WATERVUE

643-651 HUNTER STREET NEWCASTLE NSW 2300

DEVELOPMENT APPLICATION SHEET LIST		
DRAWING NO.	TITLE	REVISION
DA000	PLAN - LOCATION & DRAWING SCHEDULE	F
DA002	SITE ANALYSIS	B
DA003	PREDICT LOCATION PLAN	C
DA005	SITE PLAN	B
DA006	SHADOW DIAGRAMS	B
DA007	SHADOW DIAGRAMS	B
DA008	SHADOW DIAGRAMS	A
DA009	SOLAR ACCESS DIAGRAM	B
DA010	VENTILATION DIAGRAMS	B
DA011	PLANNING - GFA	C
DA012	UNIT AREA FOR CARPARKING GEN.	B
DA101	GROUND FLOOR	E
DA102	PARKING LEVEL 1	D
DA103	PARKING LEVEL 2	C
DA104	PARKING LEVEL 3	C
DA105	PLAN - PODIUM	E
DA106	PLAN - TYPICAL LOWER	D
DA107	PLAN - TYPICAL UPPER	C
DA111	PLAN - PENTHOUSES	B
DA112	ROOF	B
DA200	STREETSCAPE ELEVATIONS	B
DA201	ELEVATIONS - NORTH AND EAST	F
DA202	ELEVATIONS - SOUTH AND WEST	C
DA301	SECTIONS	C
DA321	RAMP SECTION CARPARK	C
DA401	PERSPECTIVE	B
DA402	PERSPECTIVE	B
DA403	PERSPECTIVE	B
DA409	MATERIALS + FINISHES	B
DA801	PODIUM LEVEL PRIVACY SCREENS	A
DA802	SIGNAGE DESIGN INTENT	A

3 L-11 - TYPICAL UPPER - UNIT AREA FOR CARPARKING GENERATION

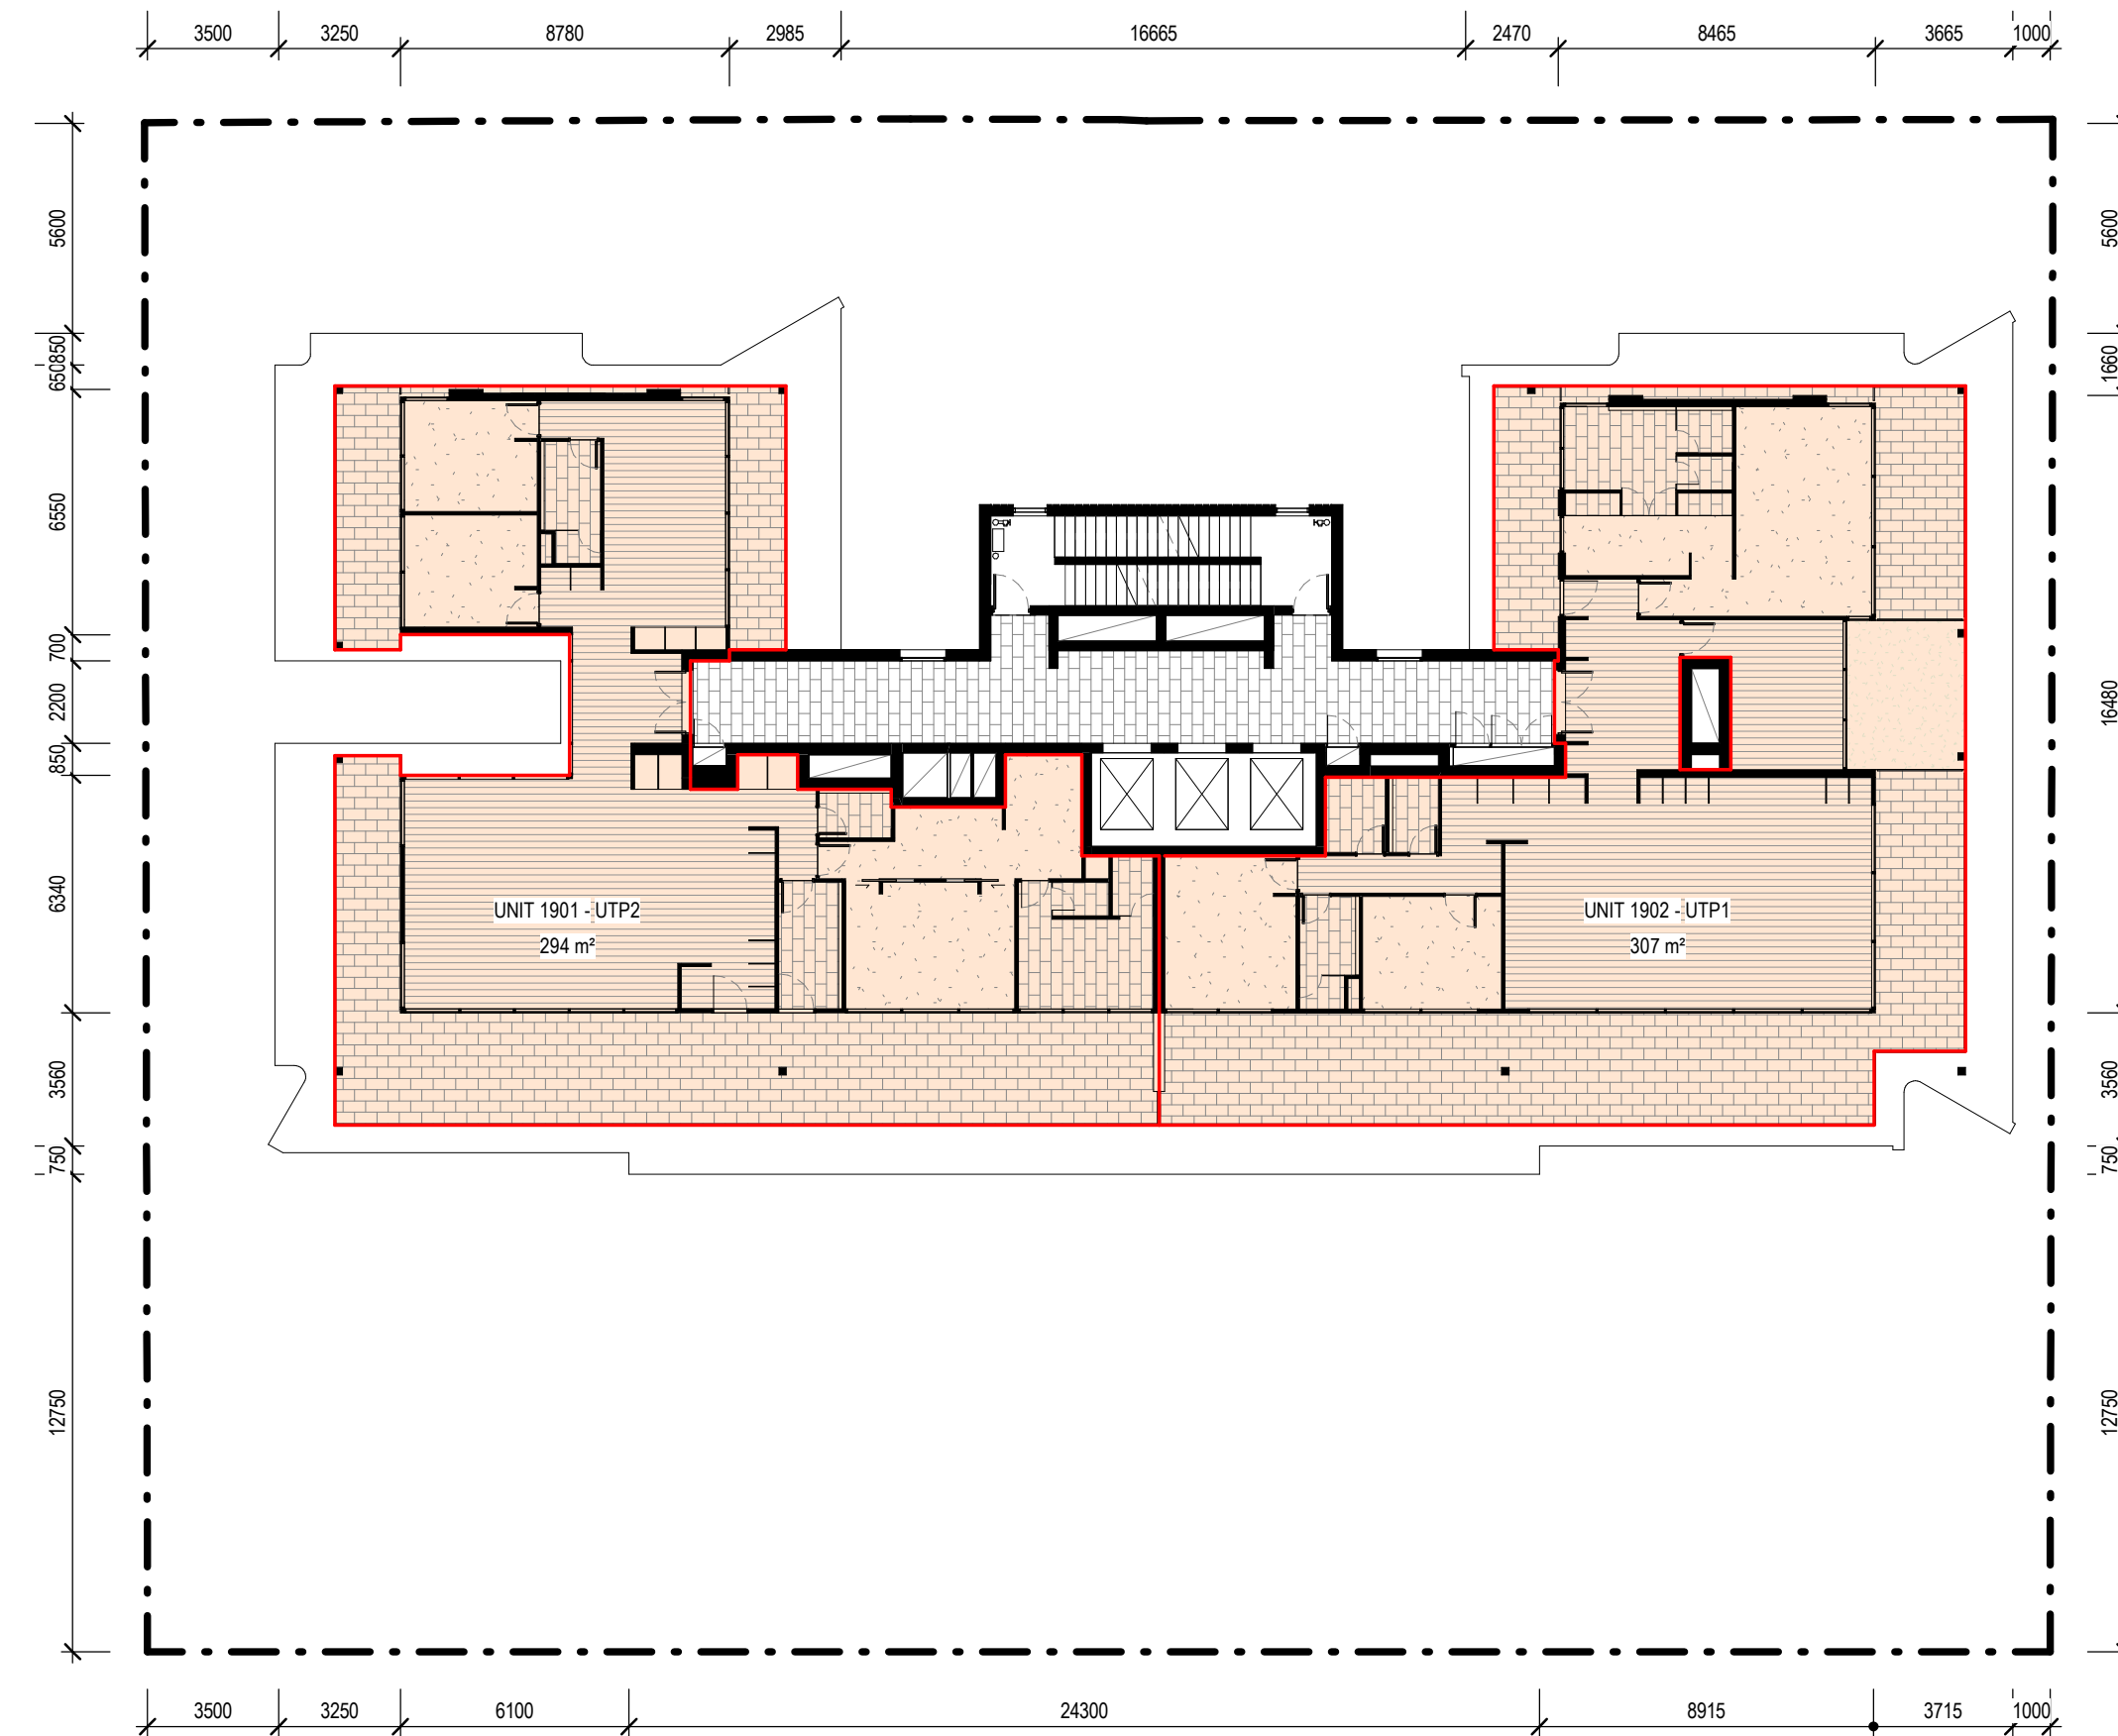
- NOTCHES IN AWNING ADDED
- FUTURE STREET TREE CLEARANCE INDICATED
- ADDITIONAL RAMP SECTION PROVIDED
- RAMP EDGE CONDITION CLARIFIED
- COMMERCIAL TENANCY STORAGE, WICS, COMMS ROOM, MAIL ROOM RECONFIGURED TO CREATE FLOOD EVACUATION PATH
- STAIRS REMOVED
- STAIRS REMOVED RAMP ADDED
- GFA REVISED AS PER CHANGES ABOVE

DRAWING No. **DA102**
DRAWING TITLE **PARKING LEVEL 1**
SCALE **1:100 @ A1**
DATE **2022**

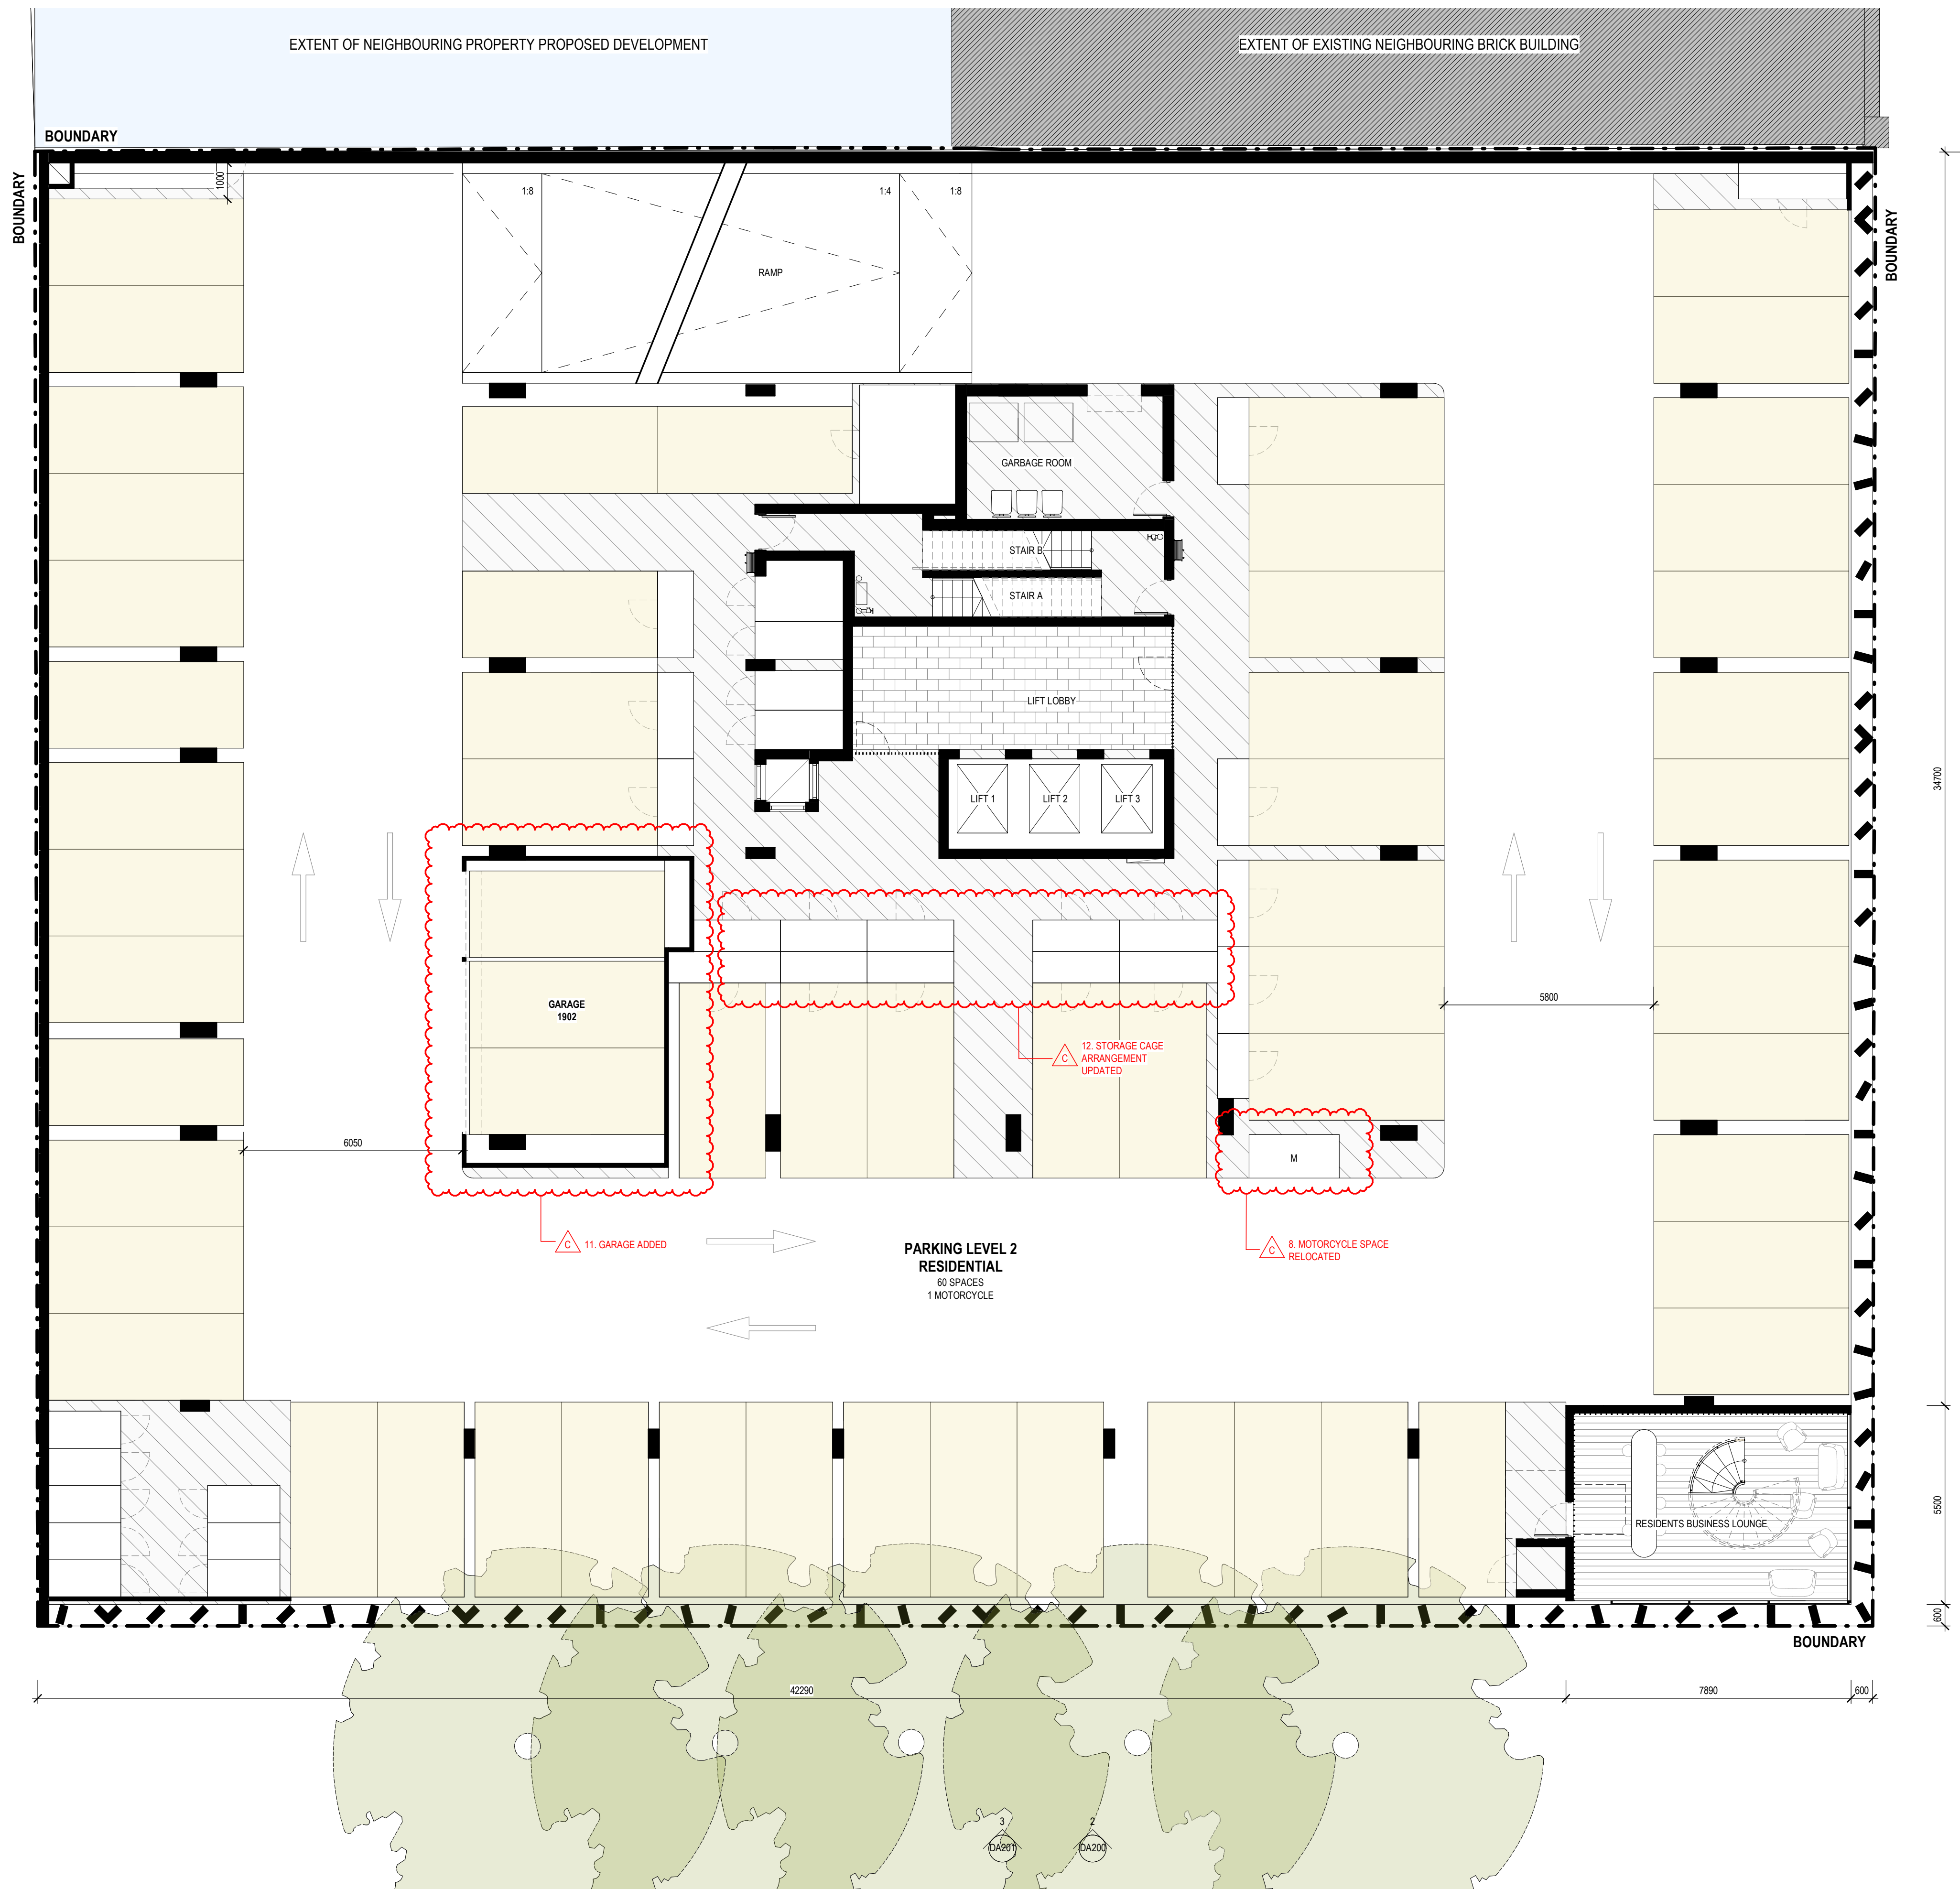
- GROUND FLOOR CARPARKING LEVEL LOWERED BY 300MM
- DRIVEWAY GRADES UPDATED TO SUIT UPDATED PARKING LEVEL
- DOOR TO FIRE EGRESS CORRIDOR RELOCATED
- STEP ADDED TO FIRE EGRESS PATH TO SUIT UPDATED PARKING LEVEL
- STEPS AND PLATFORM ADDED TO MSB ROOM TO SUIT UPDATED PARKING LEVEL
- MAIL ROOM ADDED TO RESIDENTIAL LOBBY
- MAILBOXES RELOCATED INTO THE RESIDENTIAL LOBBY
- MOTORCYCLE SPACE DISTRIBUTION ACROSS L1, L2 AND L3 UPDATED (TOTAL REMAINS THE SAME)
- SECURE ENTRY ADDED AT BASE OF RESIDENTIAL CARPARK RAMP
- GF TO L1 RAMP LENGTH UPDATED TO SUIT UPDATED GROUND FLOOR PARKING LEVEL
- GARAGE ADDED TO L1 AND L2
- STORAGE CAGE ARRANGEMENT UPDATED
- LANDSCAPE COURTYARD ACCESS DOOR ADDED TO PODIUM LEVEL
- POOL PERGOLA SHOWN IN ELEVATION
